155041.006.002

Subject: Response to Comments Letter, February 1, 2021
Notice of Intent
Former Aerovox Facility, RTN 4-0000601

Site Plans to Accompany Notice of Intent

C 200

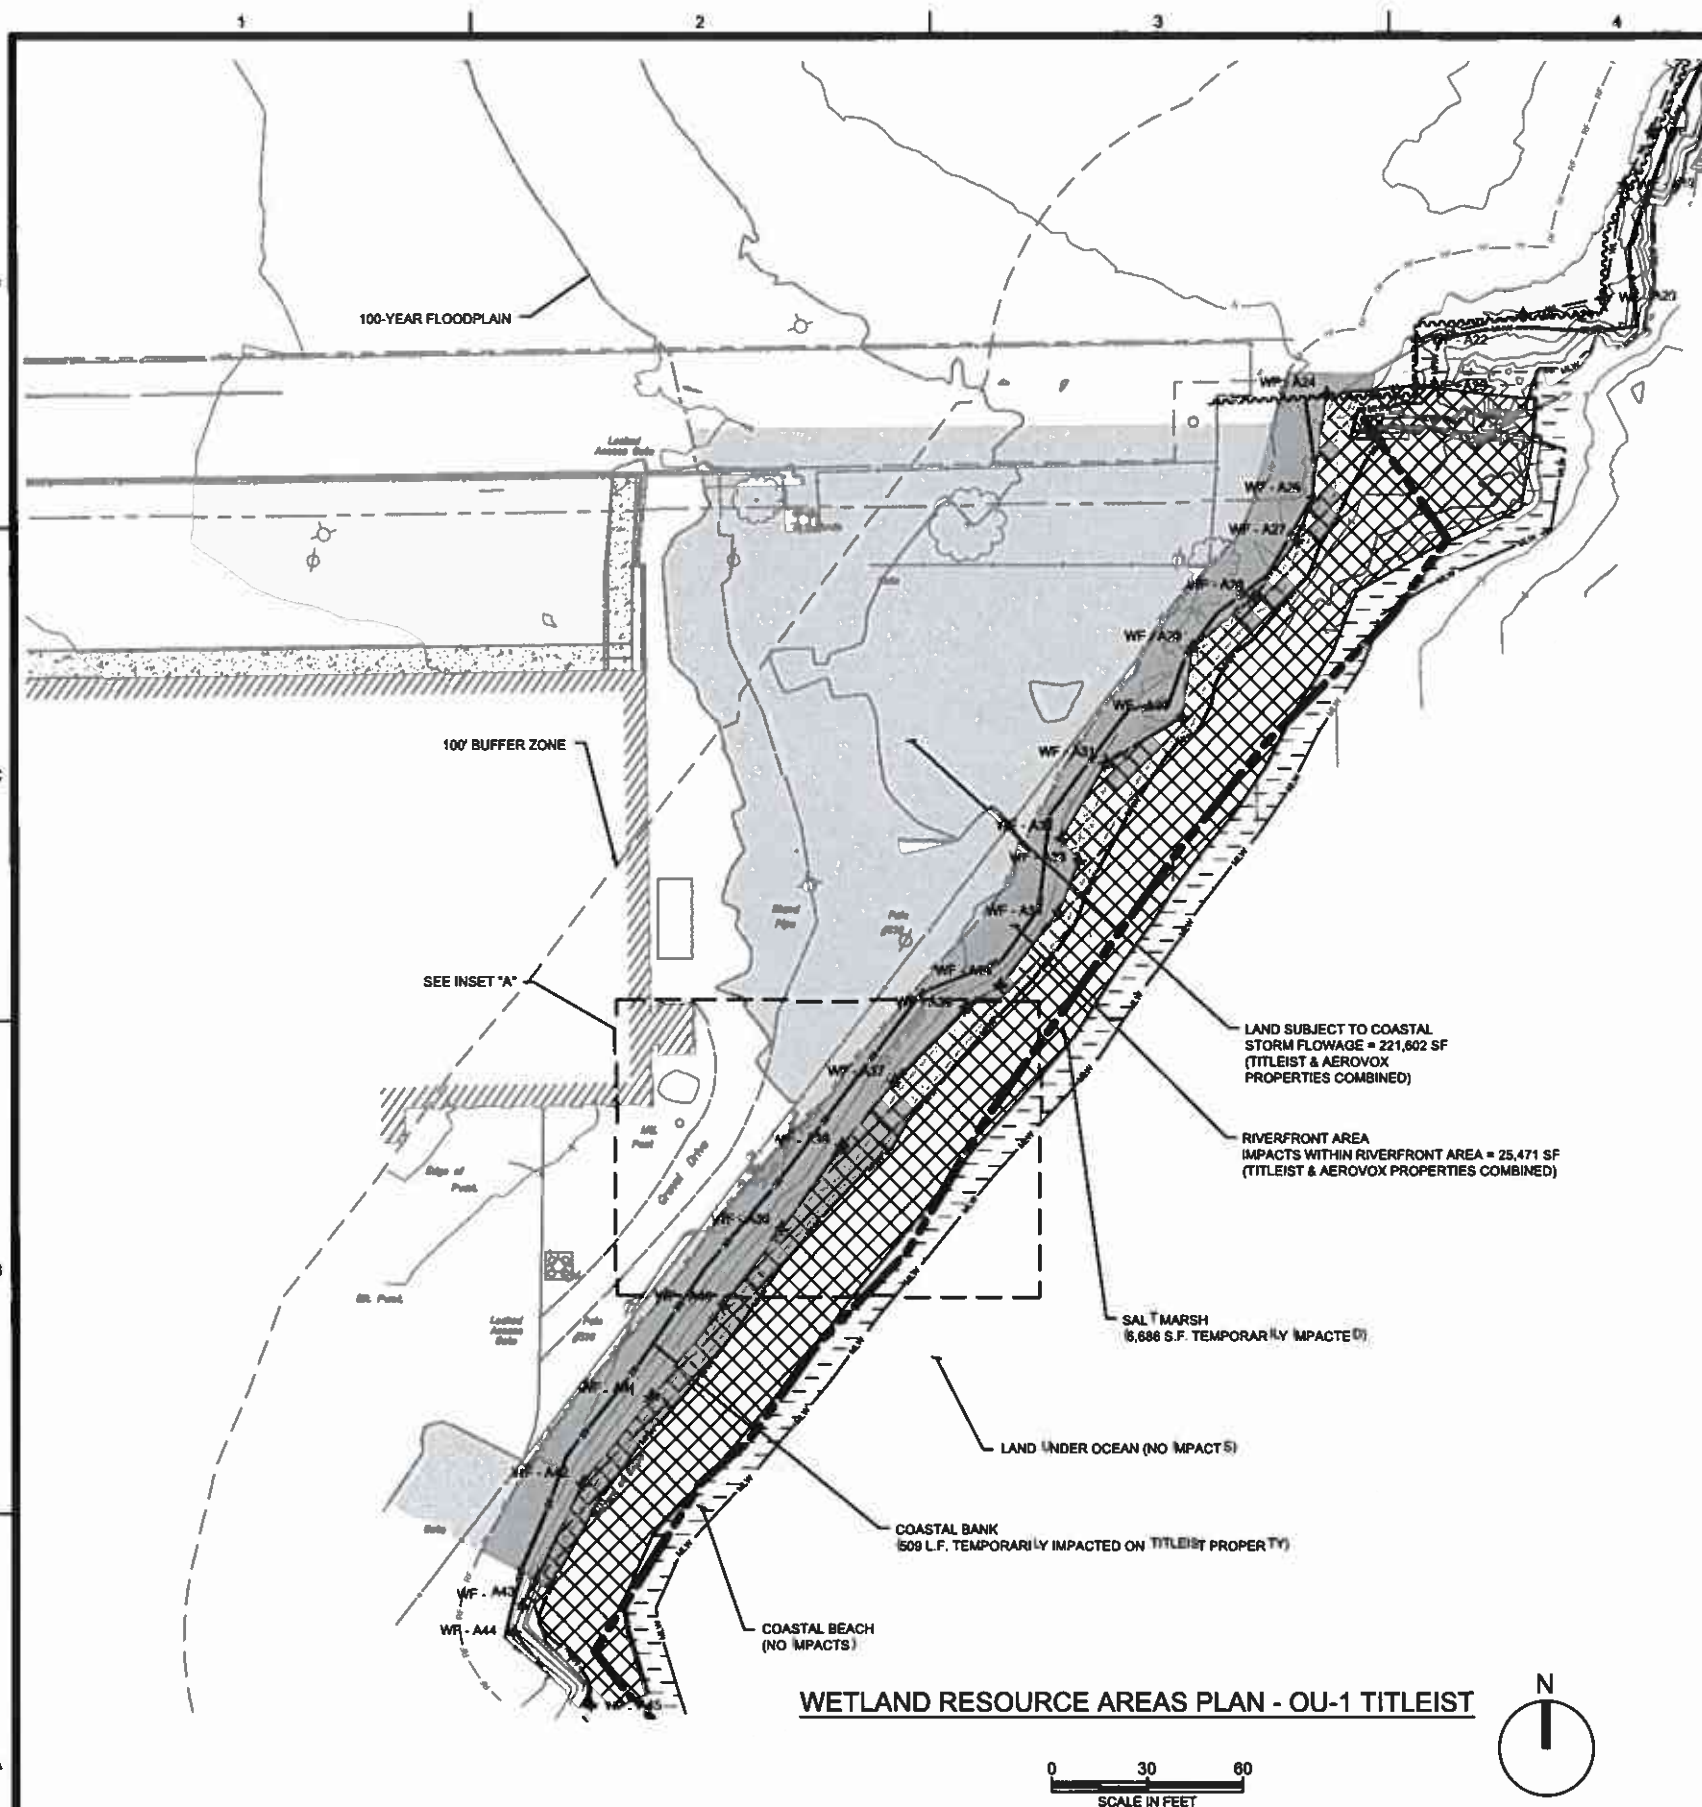
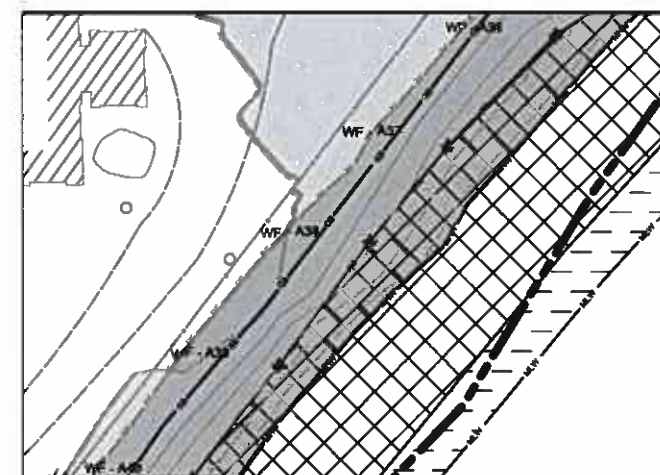
- 1. Comment:** *We recommend that the Commission request the applicant to revise the wetland delineation to show the salt marsh resource area extending up to the currently mapped boundary of BVW (i.e., HTL); there is no BVW at the site.*

2. **Comment:** *The Wetland Protection Act defines "Land Subject to Tidal Action" as "Land subject to the periodic rise and fall of a coastal waterbody, including spring tides." Spring tide elevations are higher than MHW. Therefore, if the applicant is defining Land Subject to Tidal Action as only extending to MHW, the area that is actually Land Subject to Tidal Action is likely larger than what is currently depicted on the plan in Figure 4.*

3. **Question/Comment:** *Was the 100-foot buffer zone measured from the toe or top of the coastal bank? Woods Hole Group recommends that the Commission confirm that this buffer zone was measured from the top of the coastal bank.*

35. Comment: *The definition of salt marsh in 310 CMR 10.32(2) is "a coastal wetland that extends landward up to the highest high tide line, that is, the highest spring tide of the year, and is characterized by plants that are well adapted to or prefer living in, saline soils." Based on the definition, Woods Hole Group recommends extending the salt marsh delineation landward to the HTL.*

39. General comment: *Existing wetland resource areas are not depicted on any of the site plans. Woods Hole Group strongly recommends that the Commission request a revised plan set that a) includes a clear depiction of the boundaries of all wetland resource areas present on the site, and b) clearly shows the proposed actions overlap with the wetland resource areas so specific impacts are clear.*

Response: EcoTec agrees that there is no BVW present; rather, the upper boundary of the salt marsh is marked by flags A1 to A67 (See Sheet C-200 and C-300).

On the Titleist property (Drawing C-200), the high tide line is depicted as higher than the MHW line. EcoTec flagged the upper boundary of the salt marsh resource area, which, by definition, extends landward up to the highest high tide line. The high tide-line is the landward edge of the salt marsh resource area.

Response: The 100-foot buffer zone was originally measured from the toe of slope. This line has been adjusted such that it is measured from the top of coastal bank. (See Sheet C-200 and C-300).

Response: The upper boundary of the salt marsh has been extended landward to the HTL as shown on Drawing C-200.

Response: MLW and MHW elevations in NAVD88 datum are noted on attached Drawings C-200 and C-300.

Response: An existing site conditions plan set (Drawings C-200 and C-300) has been added and is attached.
